CITY OF WEST LAKE HILLS, TEXAS
NOTICE OF CITY COUNCIL REGULAR MEETING
Wednesday, October 9, 2024 at 7:00 PM

8. Administration Discuss and consider action to approve change order number 1 for the FY24 Street Maintenance project with Alpha Paving and authorize the City Administrator to execute the same.

FY24 Street Maintenance Program

C6.0

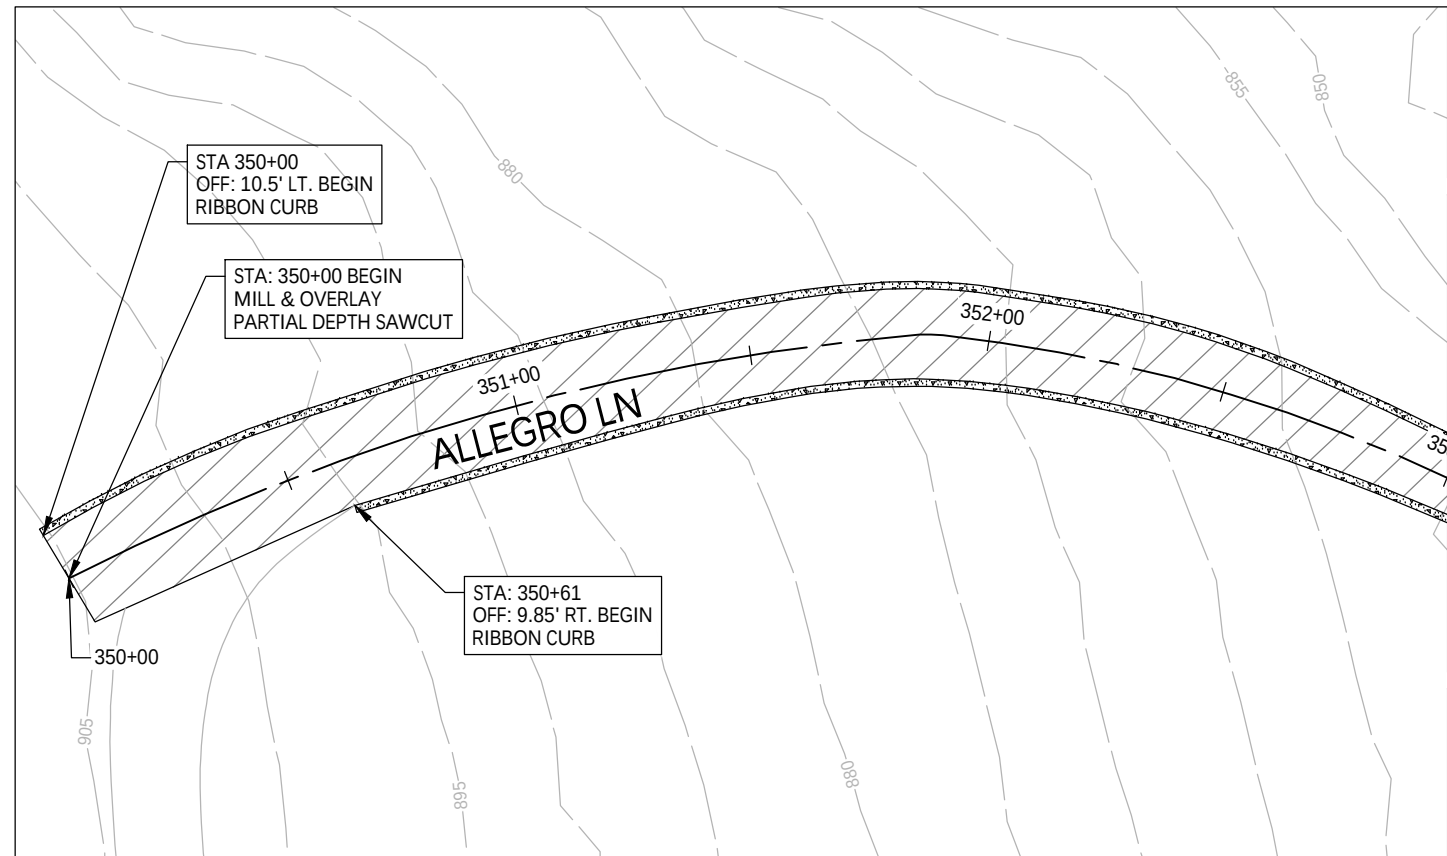
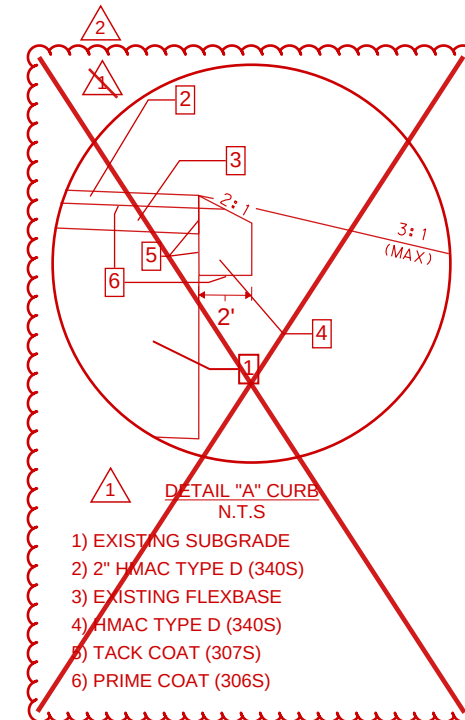
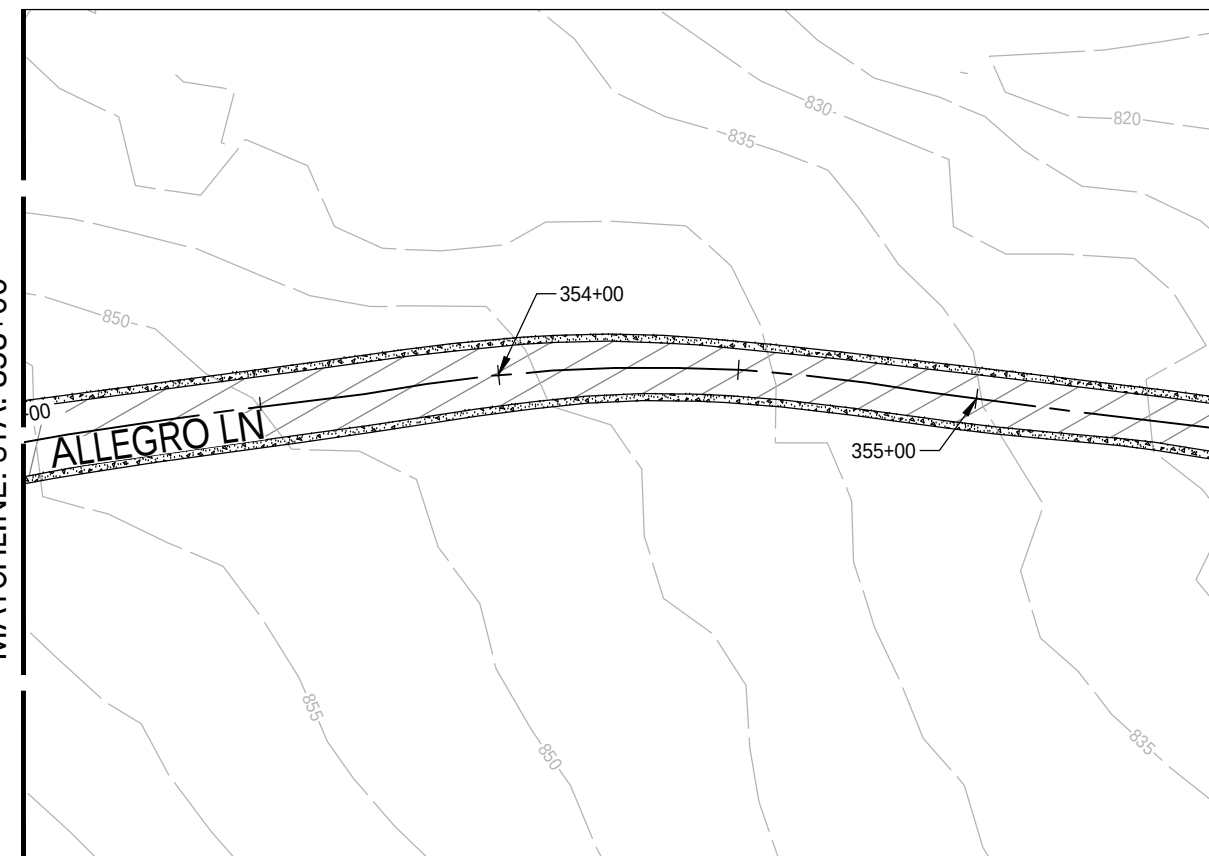
Reverse Asphalt Curb (Detail A) will not be used. COA 430S-2 Laydown "Ribbon" Curb will be used, refer to sheet C26.2 for details.

C6.1

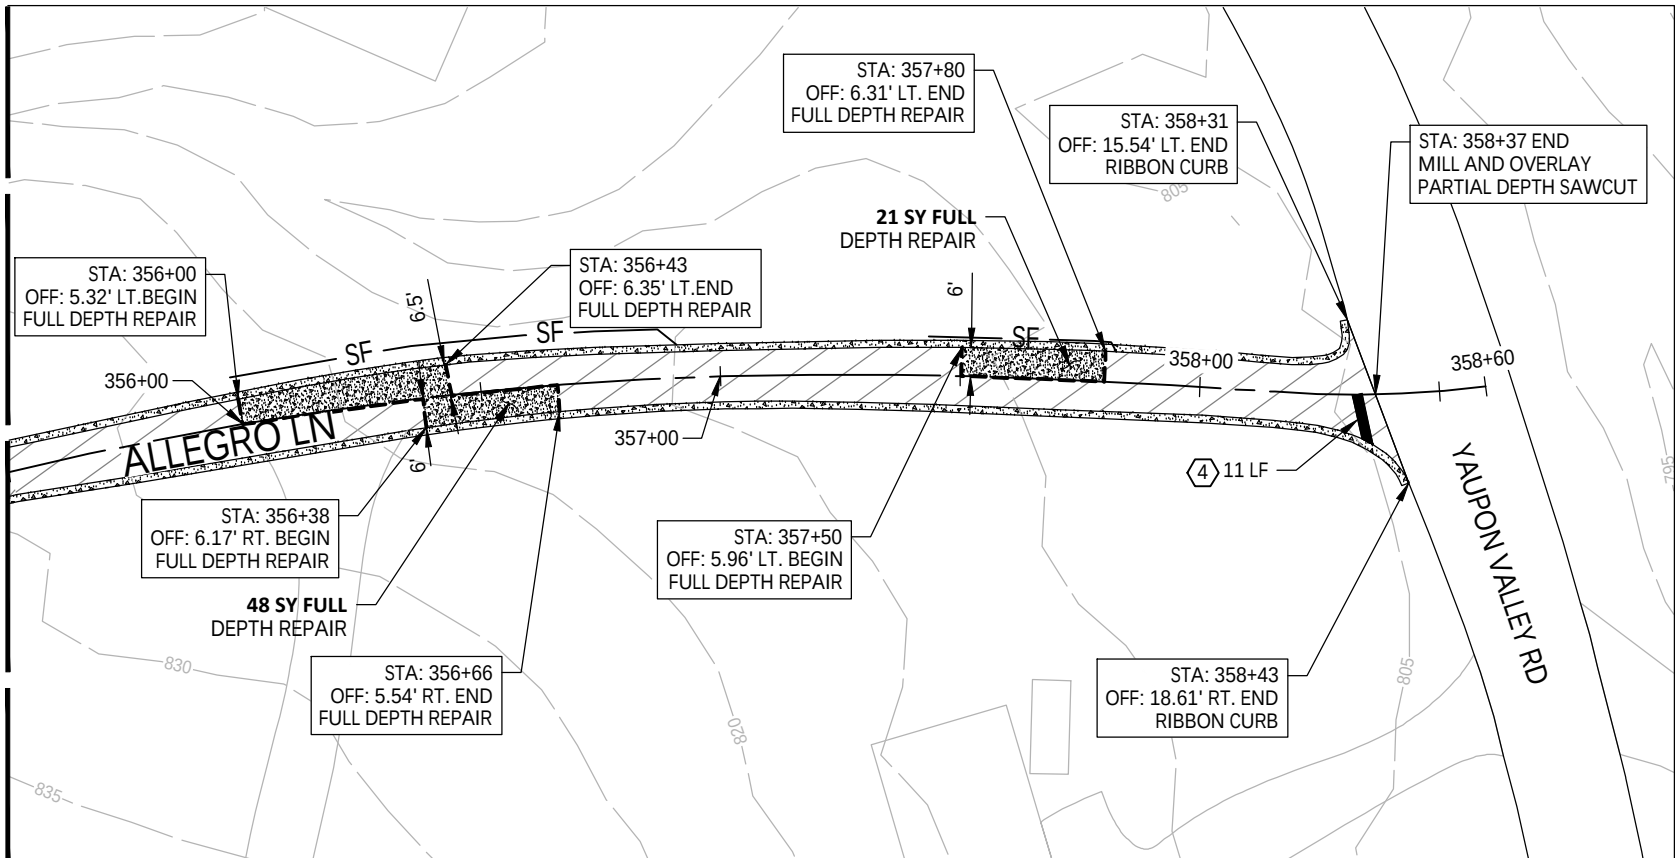
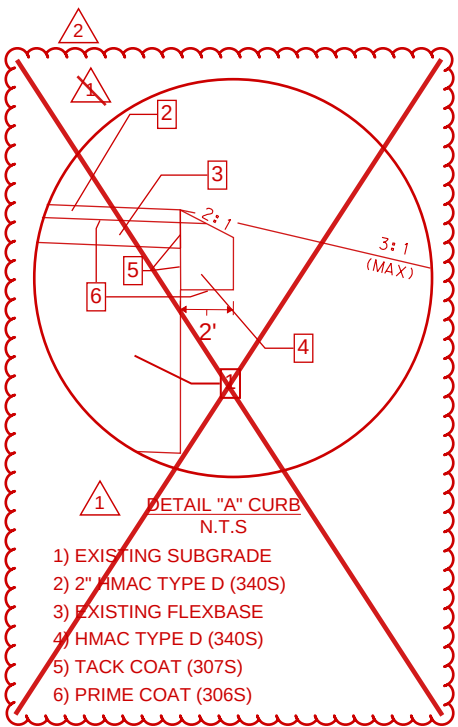
Reverse Asphalt Curb (Detail A) will not be used. COA 430S-2 Laydown "Ribbon" Curb will be used, refer to sheet C26.2 for details.

C7.0

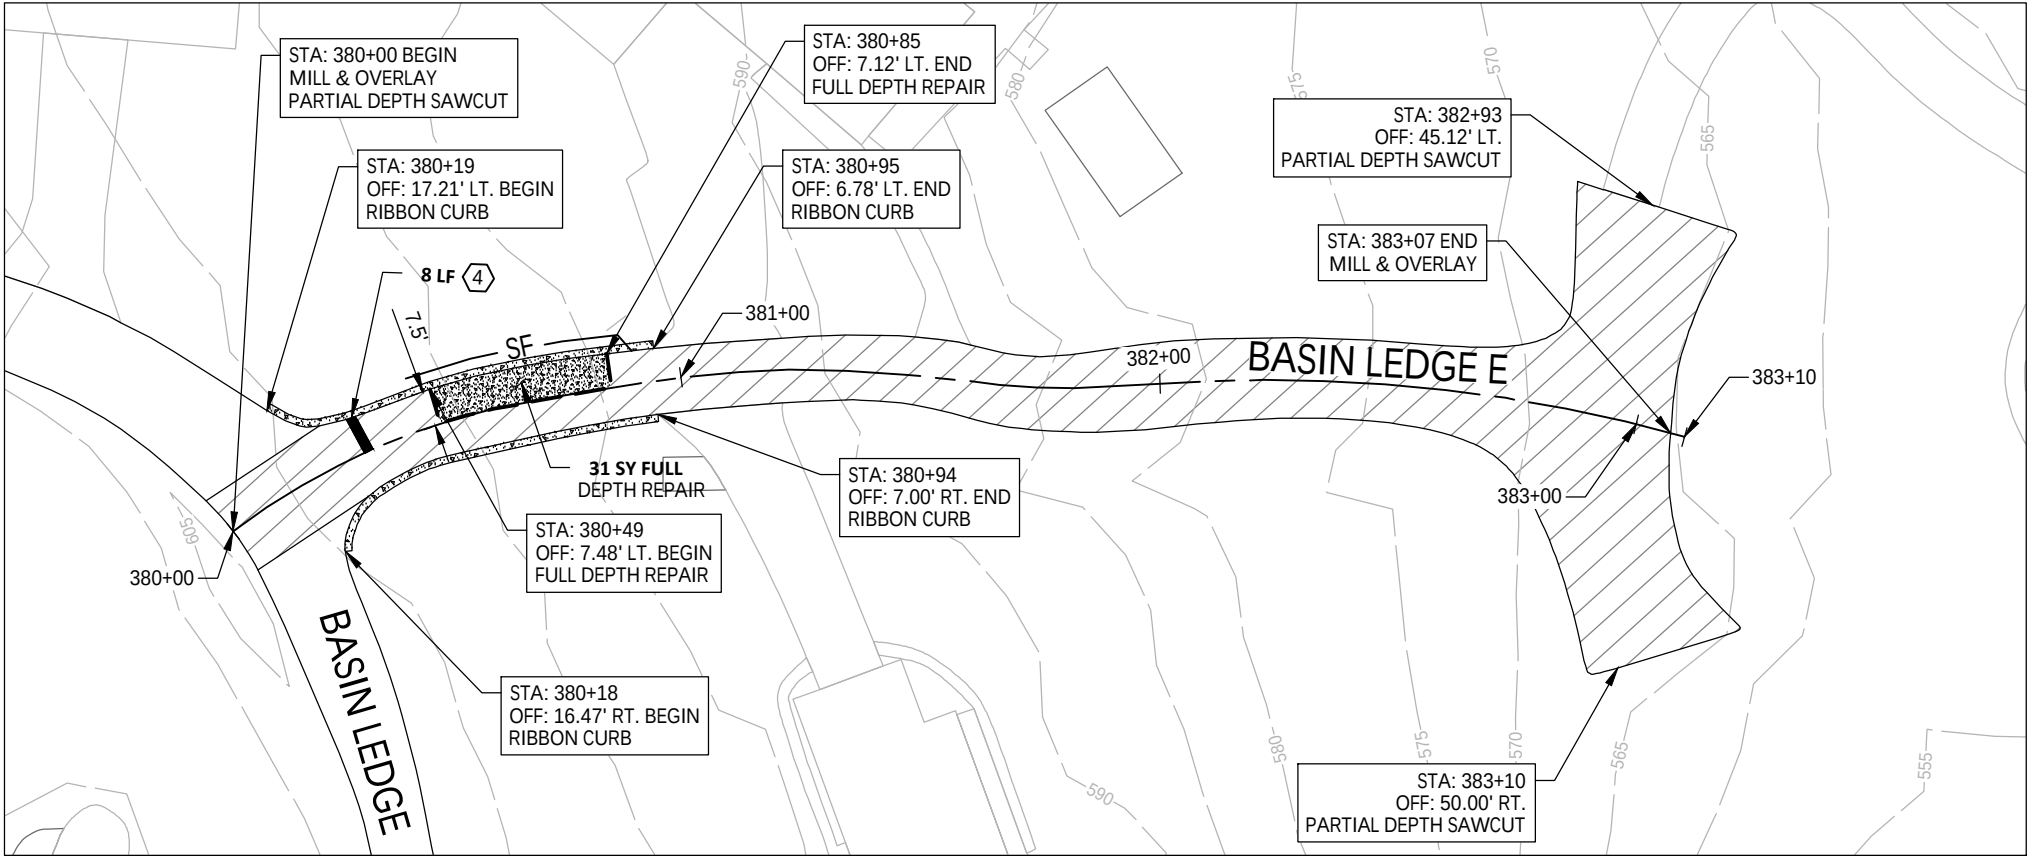
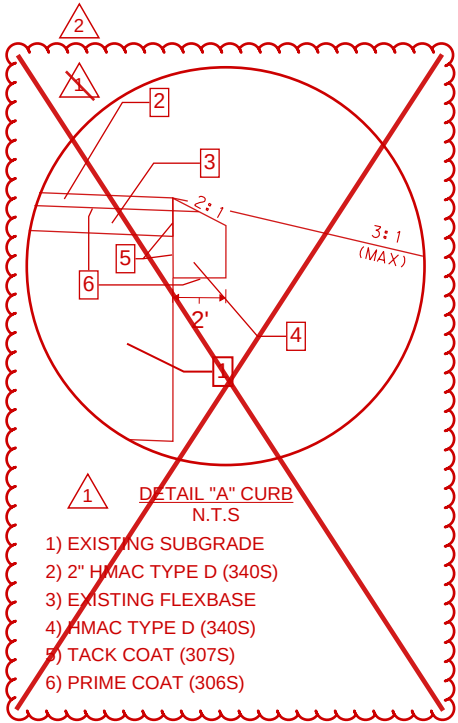
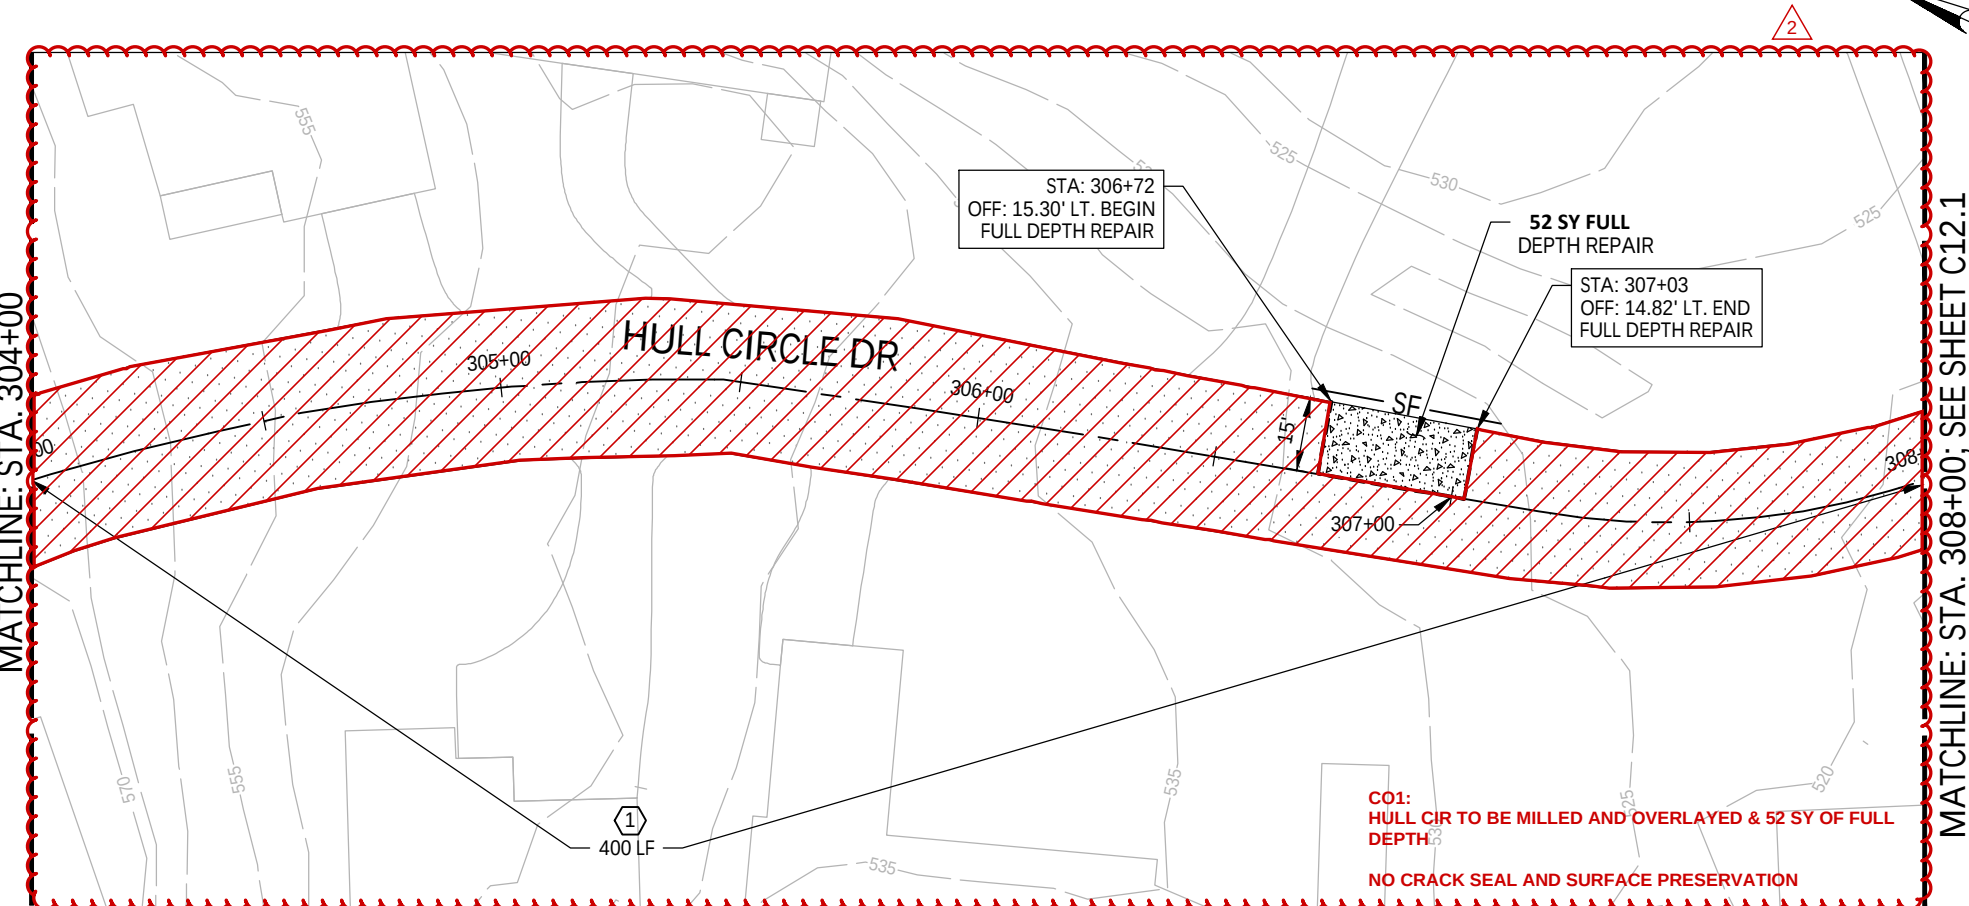
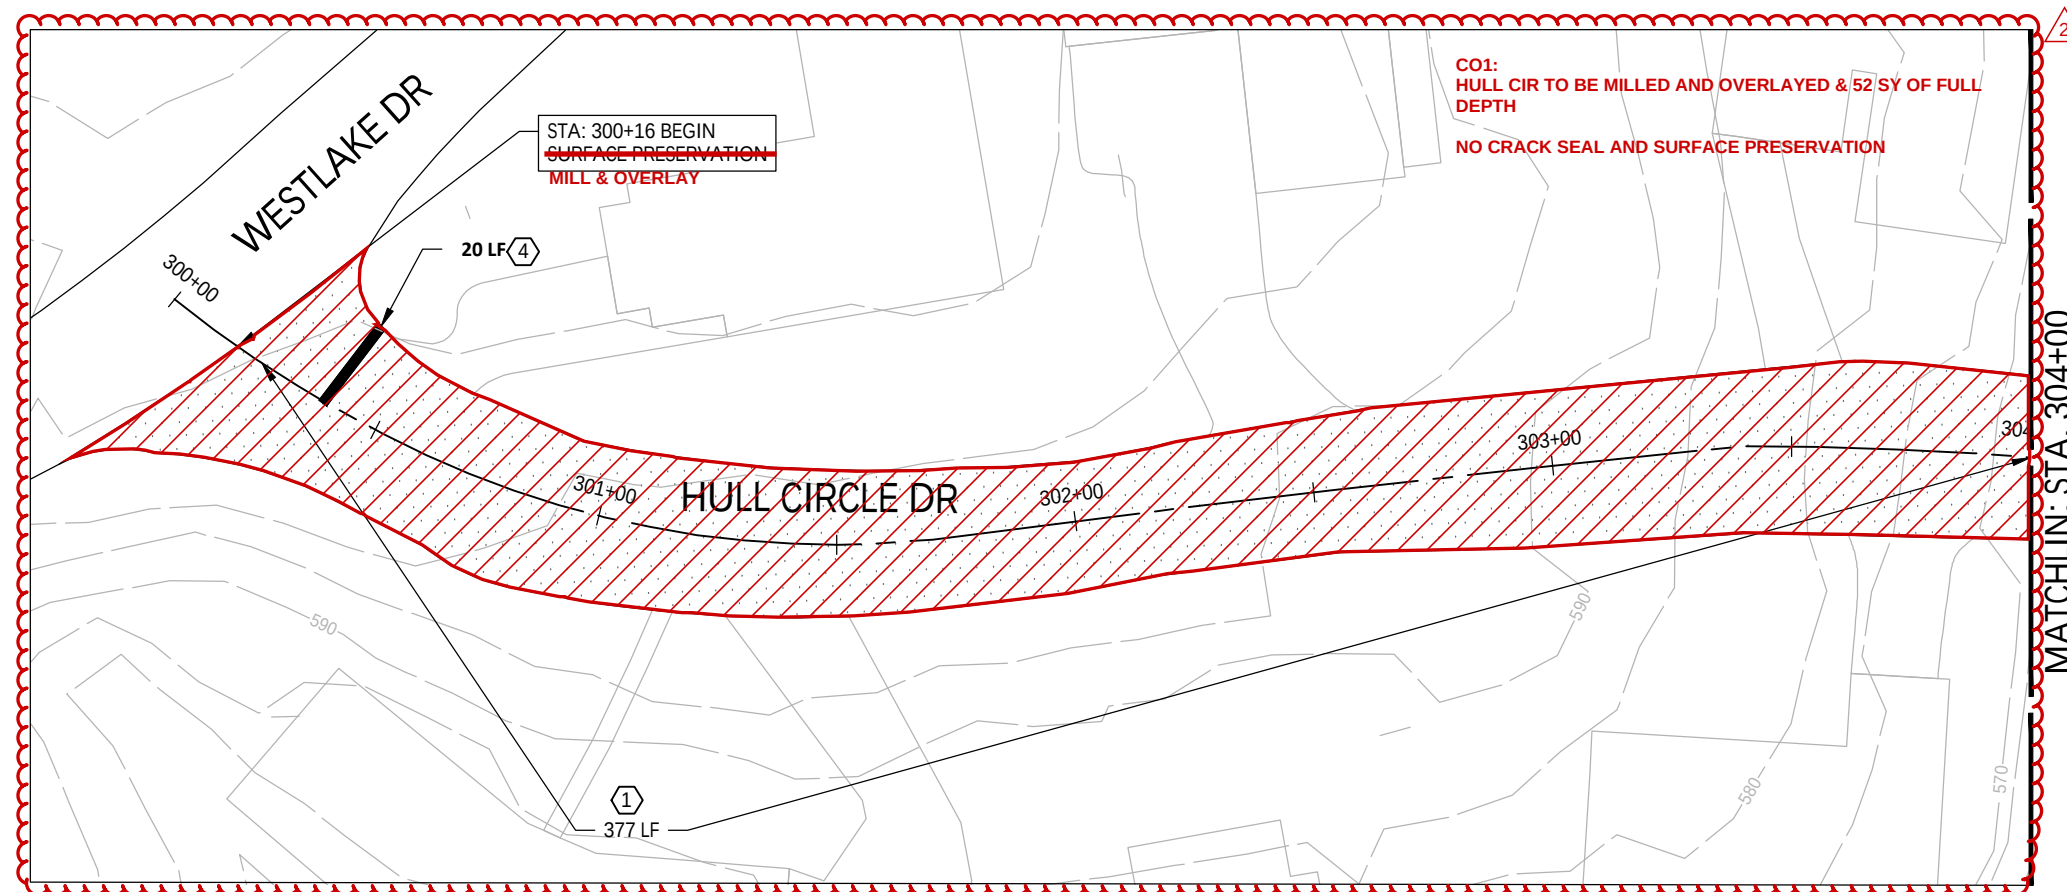
Reverse Asphalt Curb (Detail A) will not be used. COA 430S-2 Laydown "Ribbon" Curb will be used, refer to sheet C26.2 for details.
